# City of Columbia

Council Meeting Date: April 18, 2016

Re: Adoption of the 2015 International Code Council Family of Codes, with Amendments

Council Bill No. B 107-16

Section R403.1.6 Foundation Anchorage

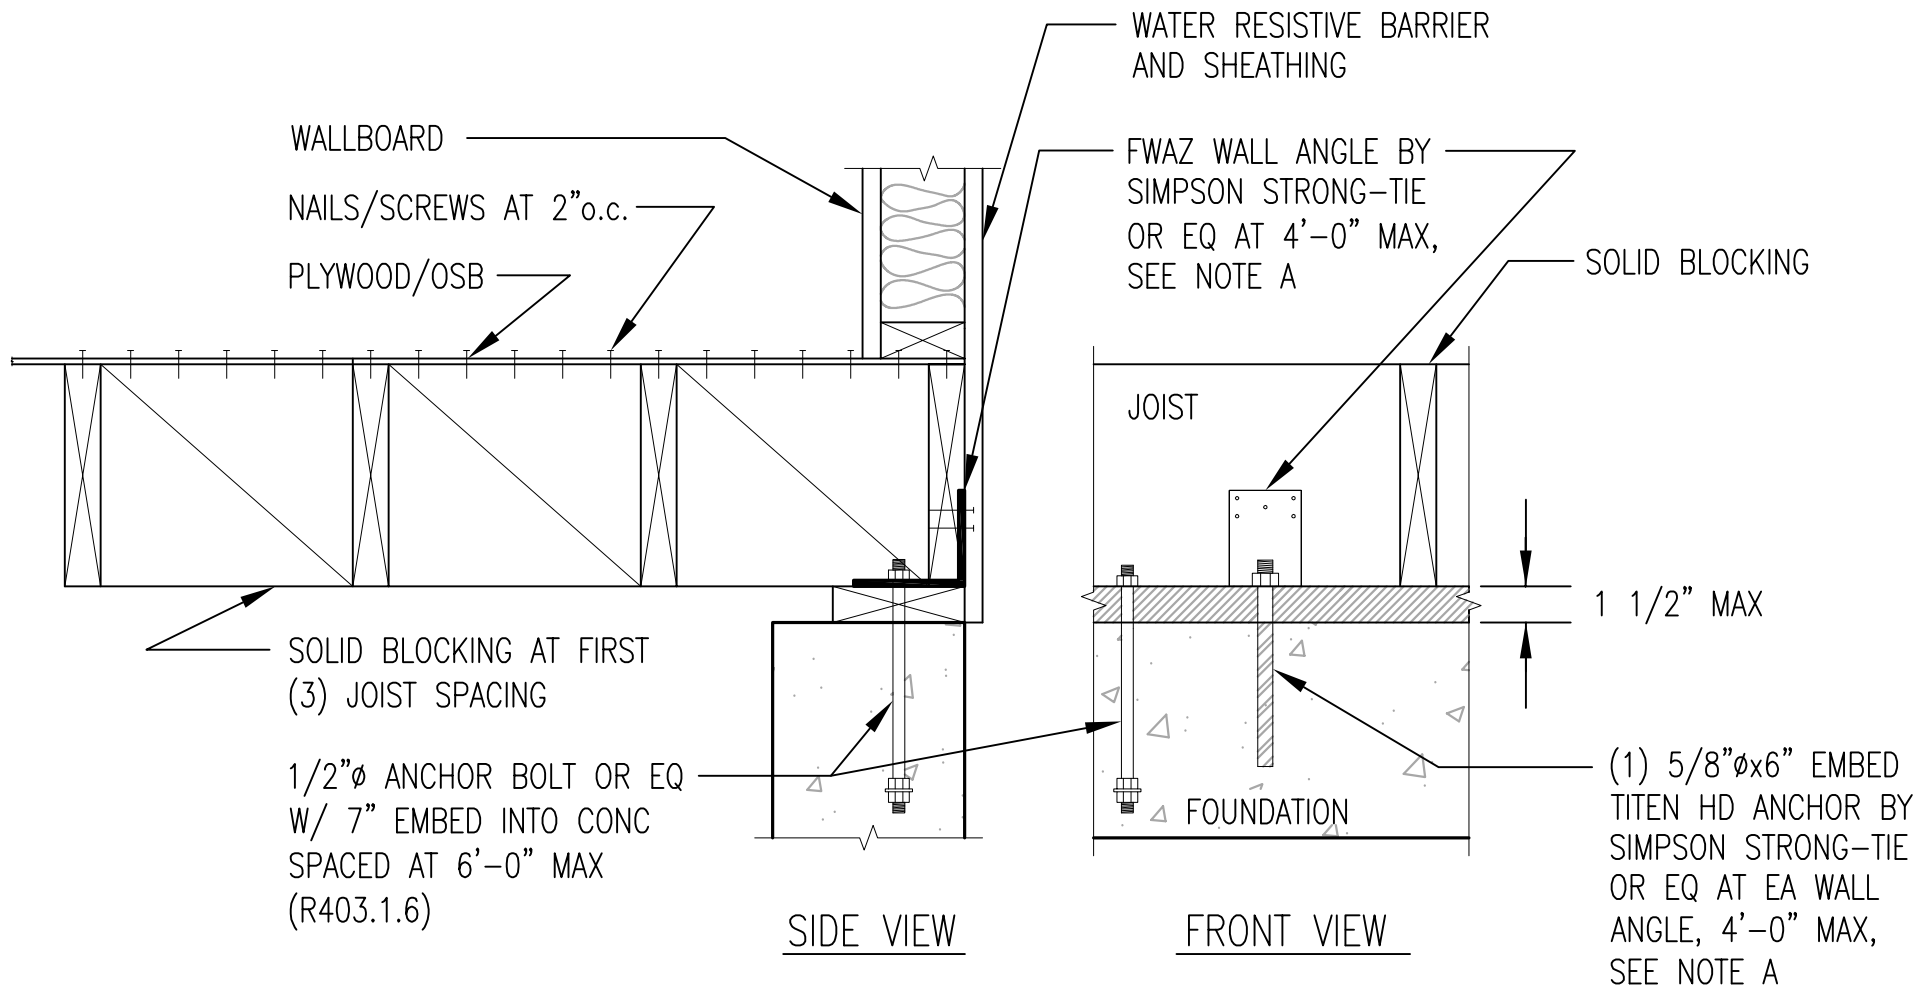
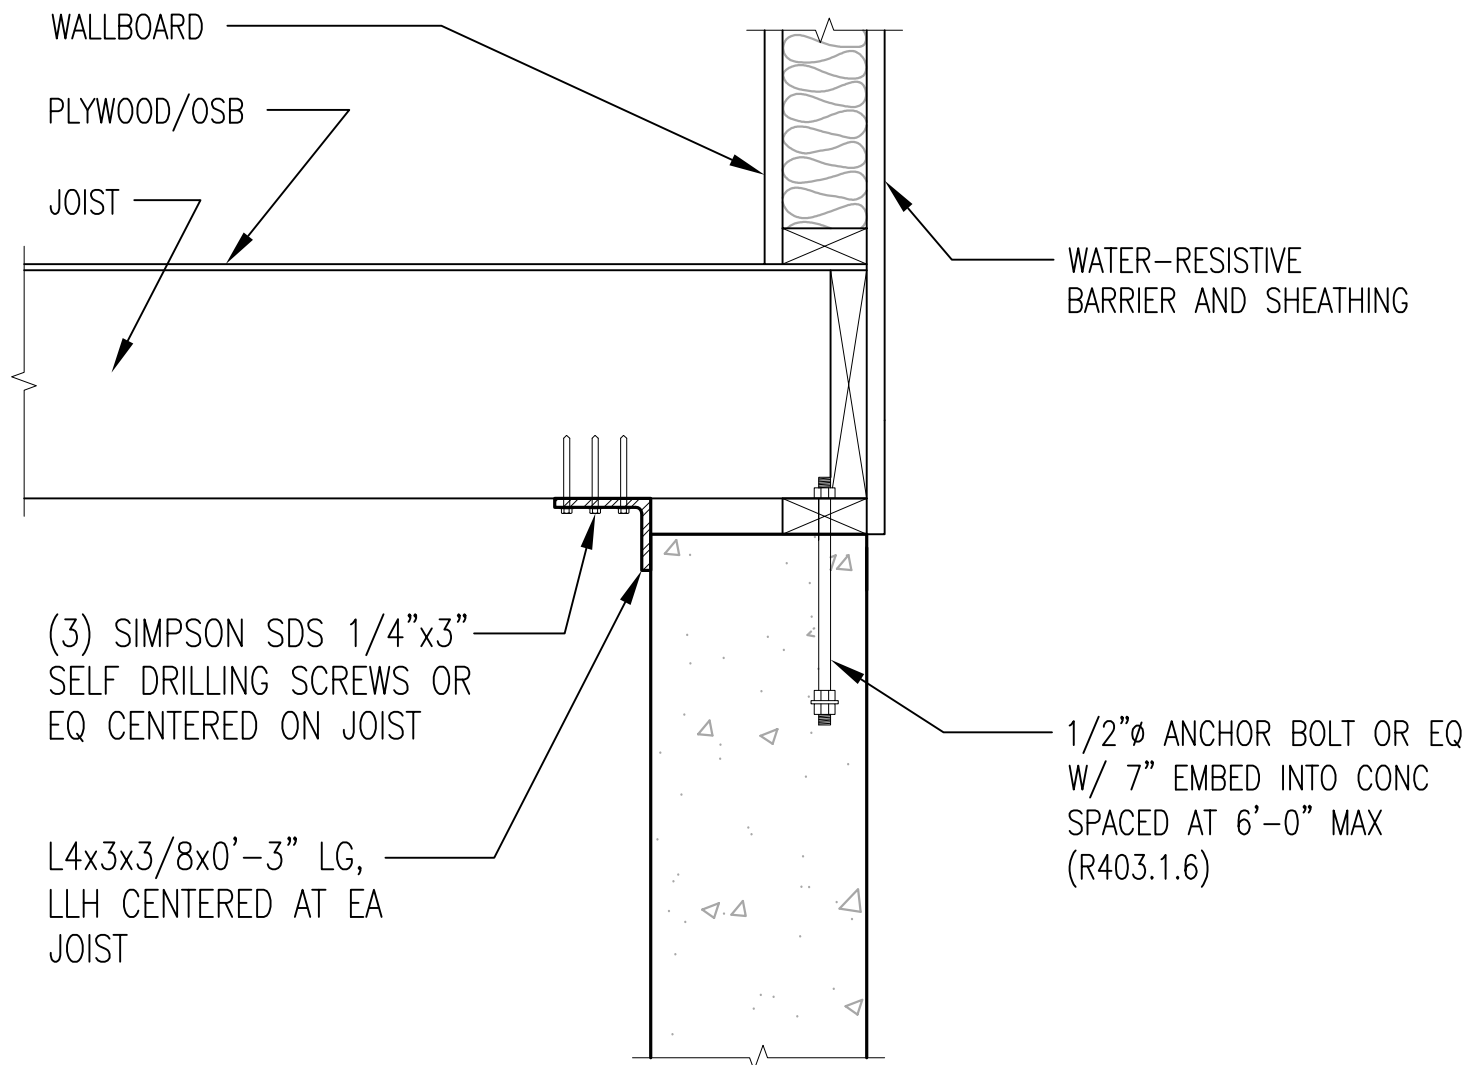
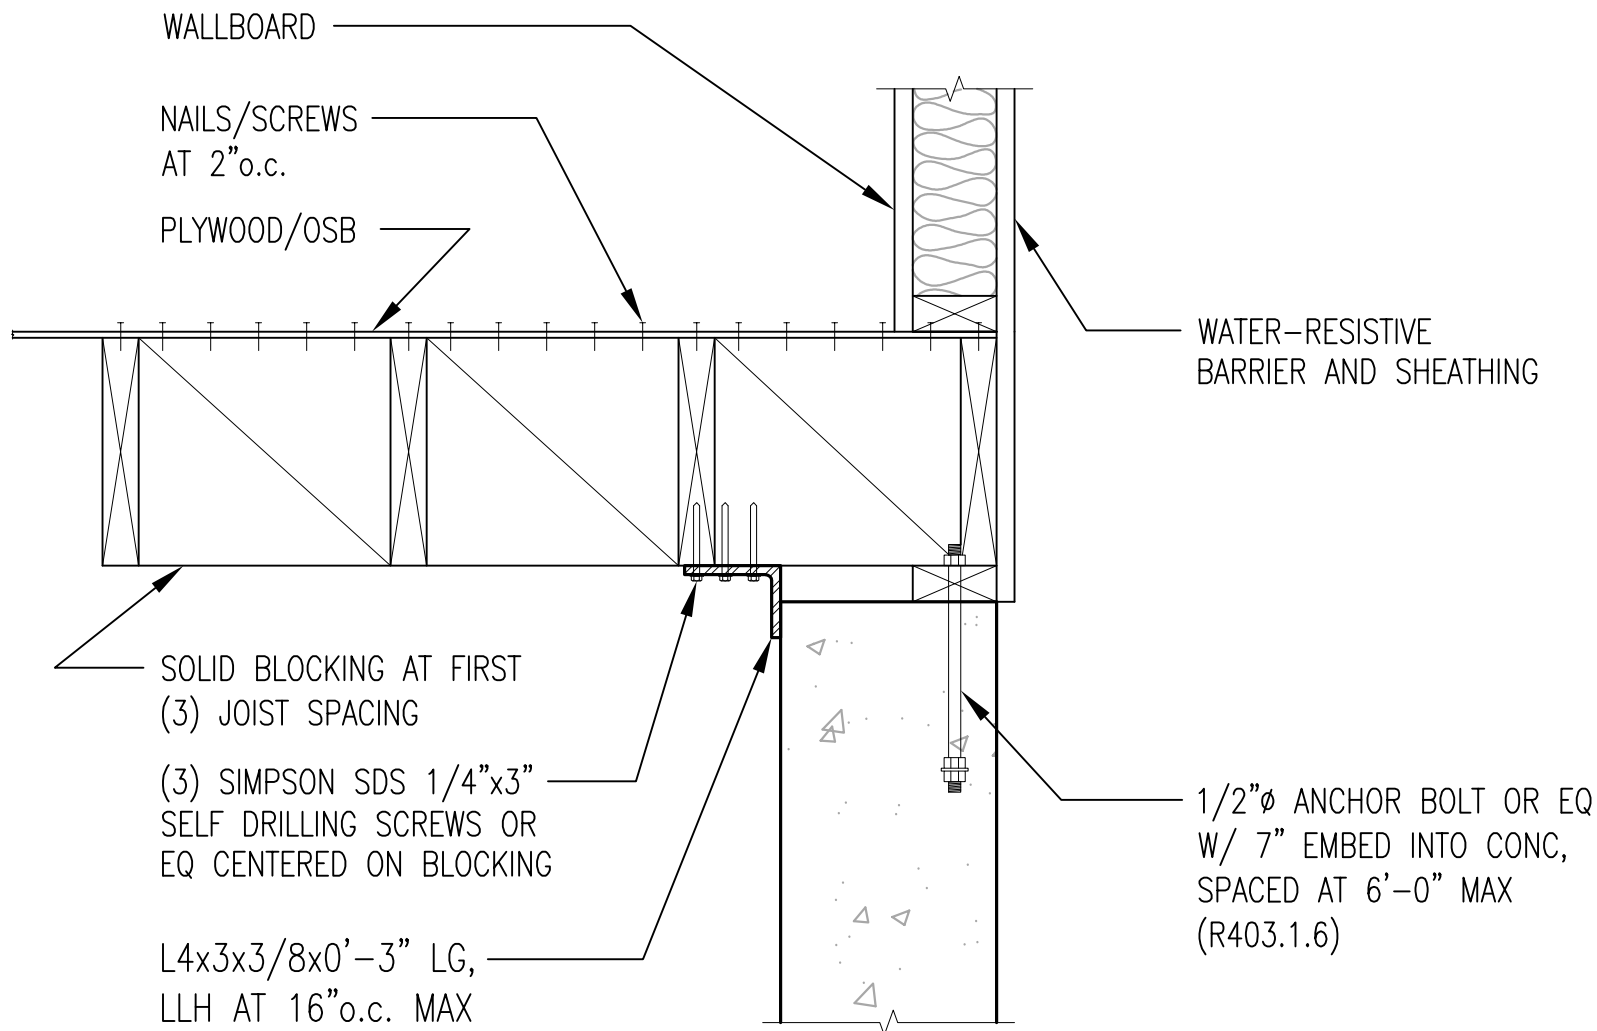
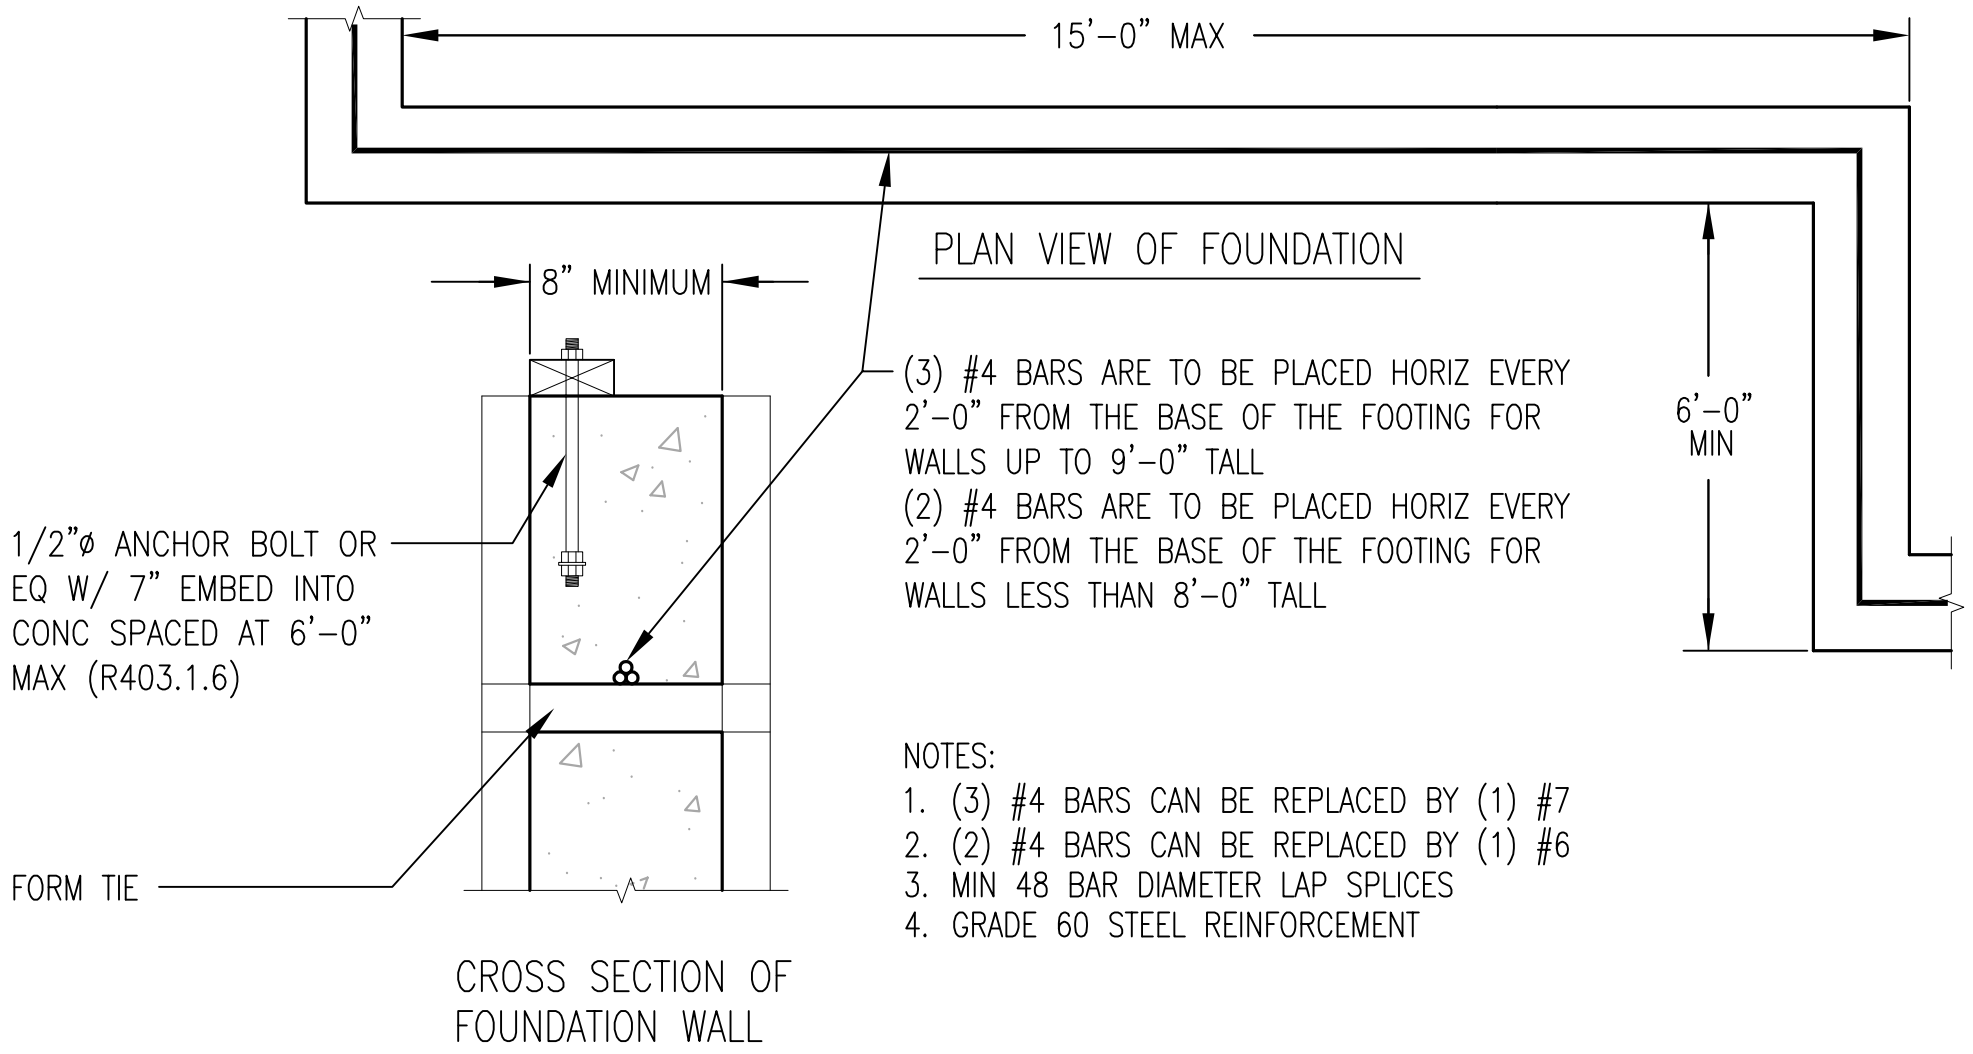
*R403.1.6 Foundation anchorage.* Add the following to the end of the section, prior to the Exceptions: The connection of the foundation walls to floors shall be per the alternatives labeled 1.1, 1.2, 1.3, 1.4, 2.1, 2.1, 3.1, 3.2 or 4.
